DRAINAGE AND TRANSPORTATION INFORMATION SHEET (REV 11/2018)

Re: US Eagle Credit Union – Menaul
7201 Menaul NE
Traffic Circulation Layout Re-Submittal
Engineers Stamp Date 11-24-20 (H19D090)

Enclosed for your review is a copy of the US Eagle – Menaul Traffic Circulation Layout. Below is a brief description of how the comments from your response letter (dated 12/03/20) were addressed:

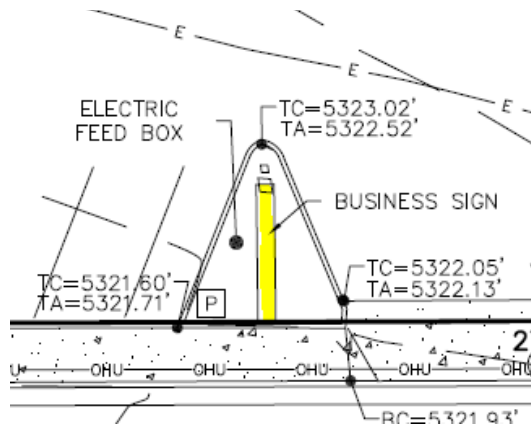
3. Espanola entrance pavement markings will need 'Do Not Enter' and the proposed pavement bar will need to be located on private property.

Response: Markings 'Do Not Enter' and stop bar have been moved onto private property.

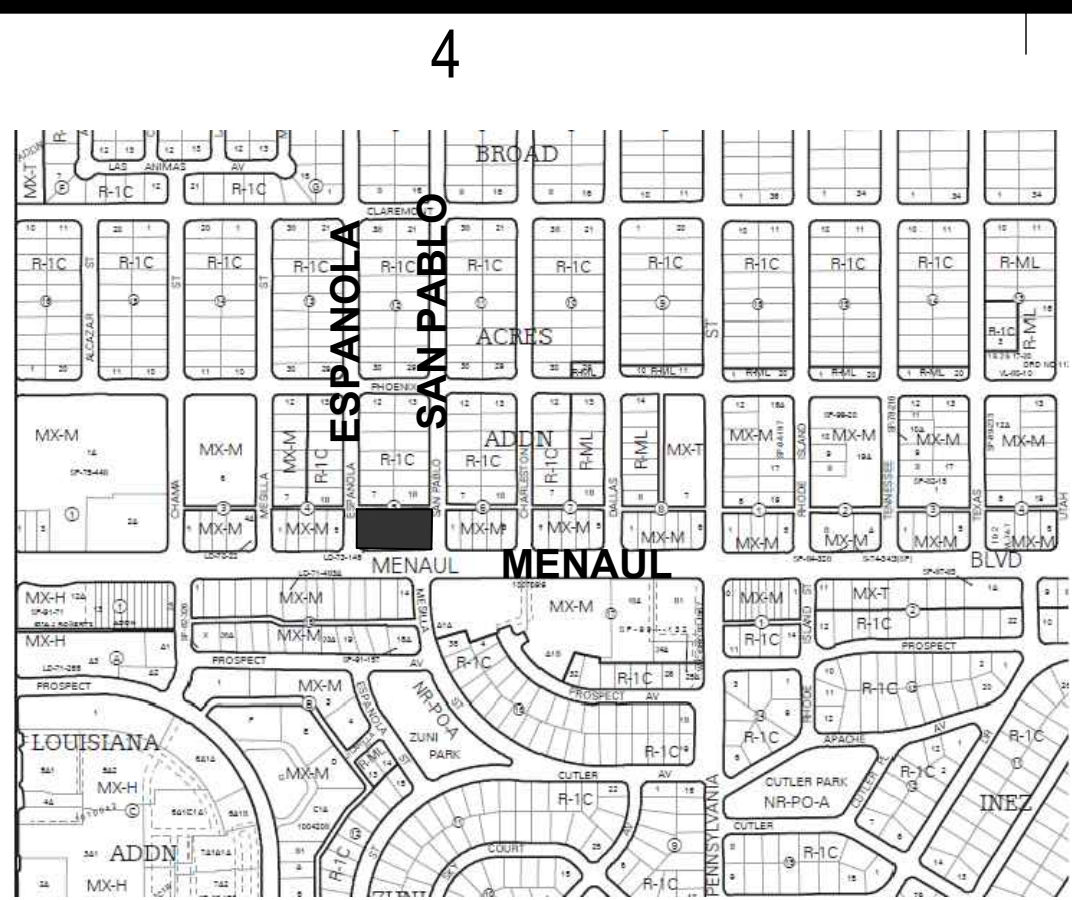
4. Please verify the existing monument air space doesn't encroach onto COA ROW.

Response: The survey located the extents of the sign, not just the base. See images below for clarification. Sign is not located in ROW.

6 PERMANENT BOLLARD
NTS

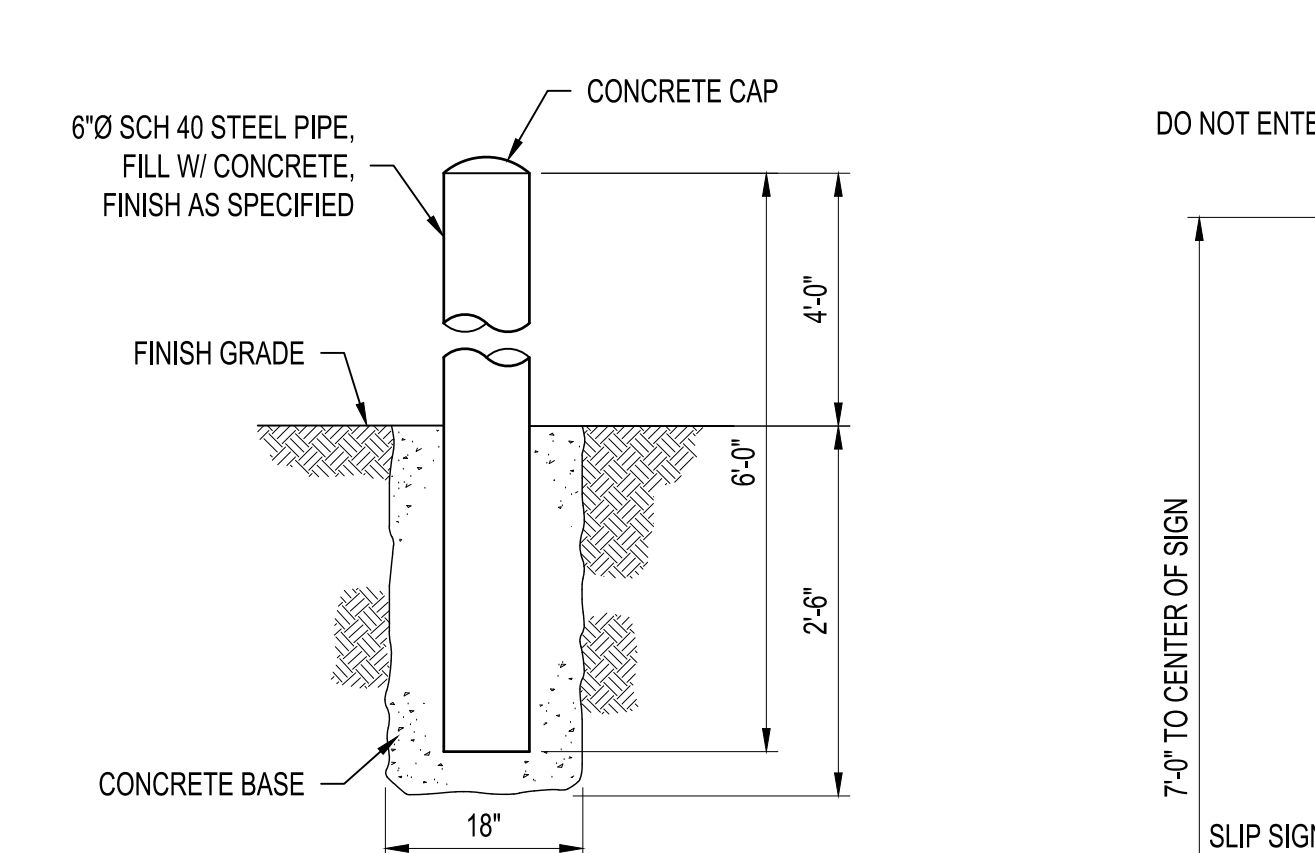
5. Add note on proposed bollard to be painted yellow.

Response: Keyed Note has been updated to have bollards painted yellow.

9 WHEEL CHAIR RAMP DETAIL
NTS

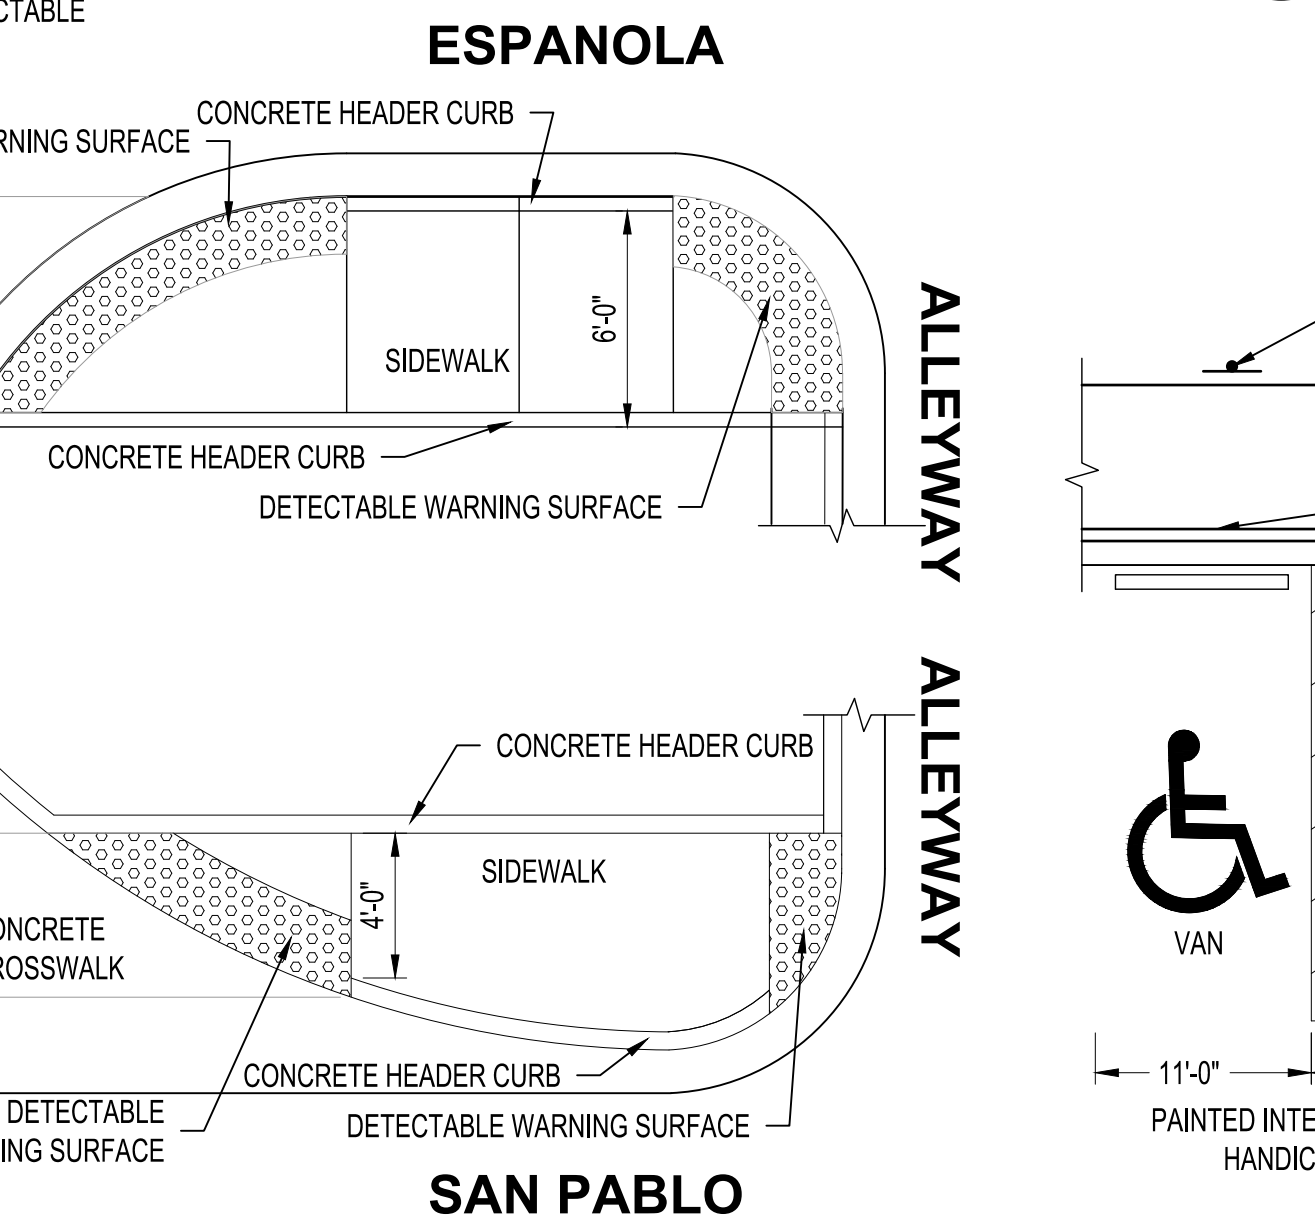
2. Add notes referencing sheet C-101 for the proposed ADA ramp status on the northern segments of Espanola St. and San Pablo St. abutting 20 ft. Alley on sheet C-100.

Response: Keyed Note 3 references the detail on C-101 regarding the ADA ramps at the Alley and Espanola St. and San Pablo St.

7 DO NOT ENTER SIGN
NTS

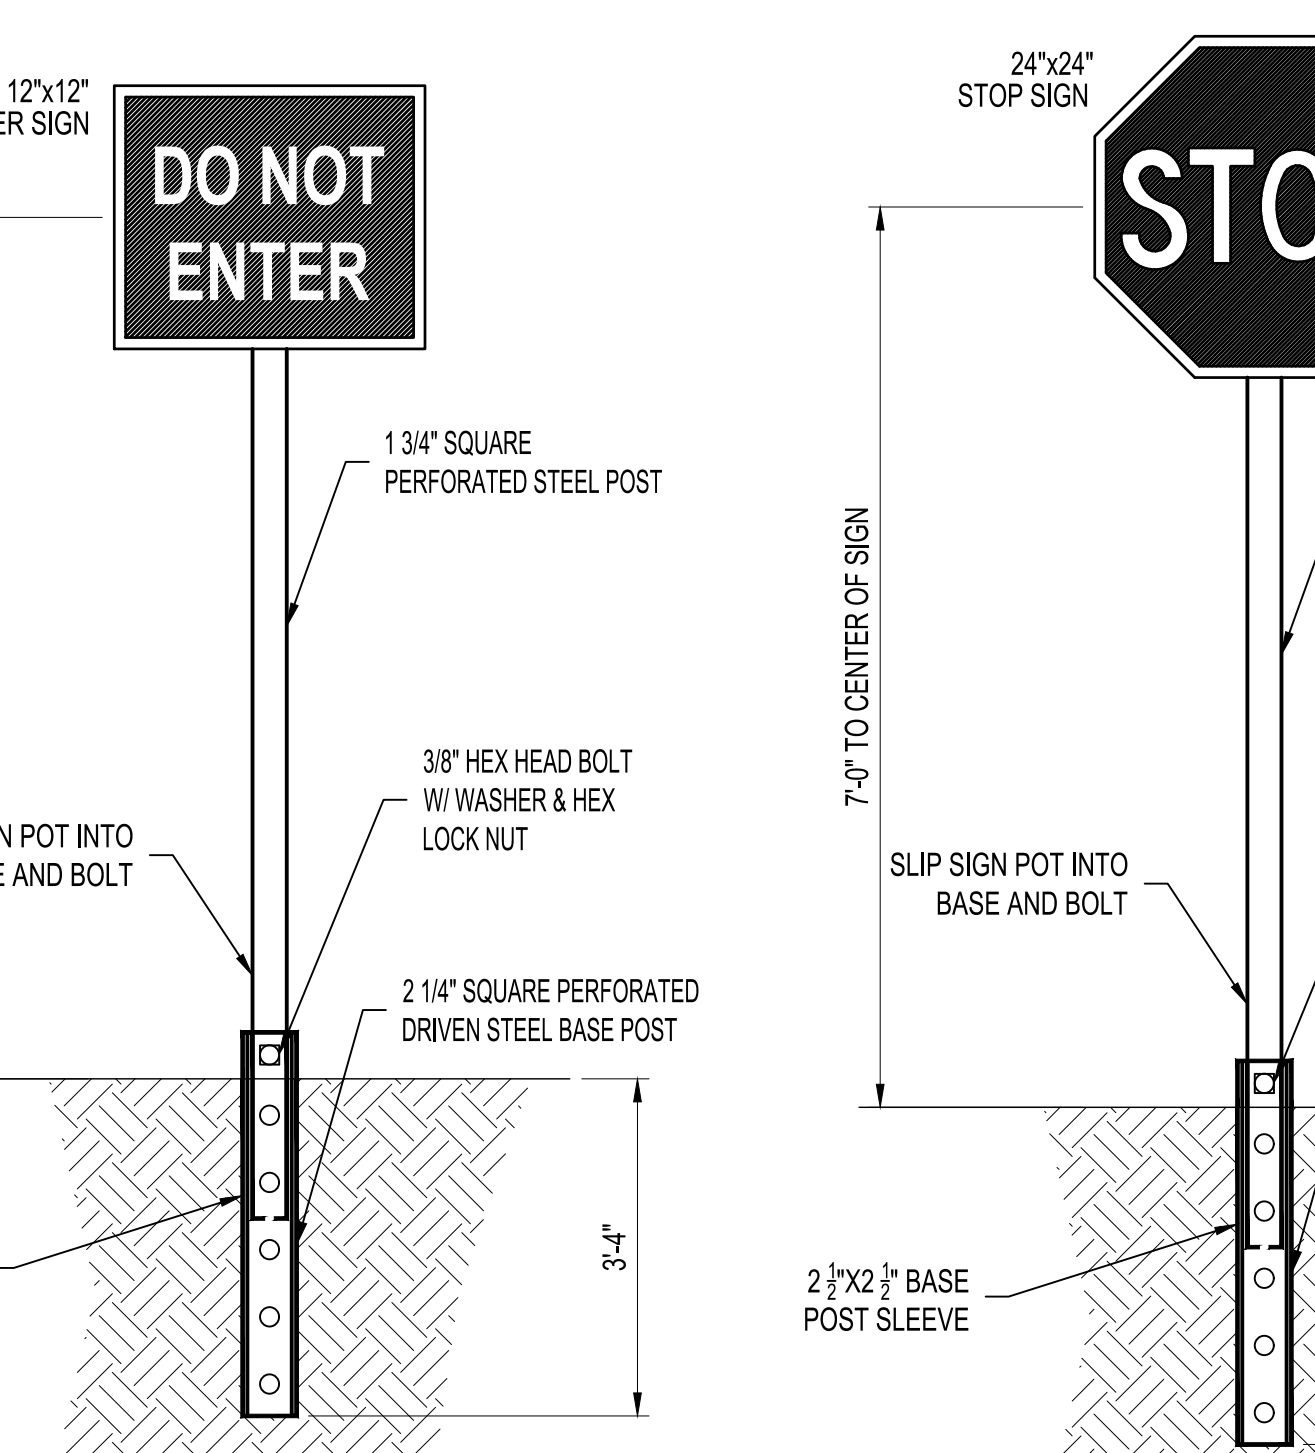
1. KEYED NOTES: All keyed notes referencing MUTCD and Architectural Plans will need details on these sheets. Please do not reference different manuals or spec's unless they are COA std dwg numbers. The proposed sign face detail will need to comply with MUTCD and detail will need to be provided.

Response: The reference to MUTCD has been removed from the Keyed Notes and details added to the plan.
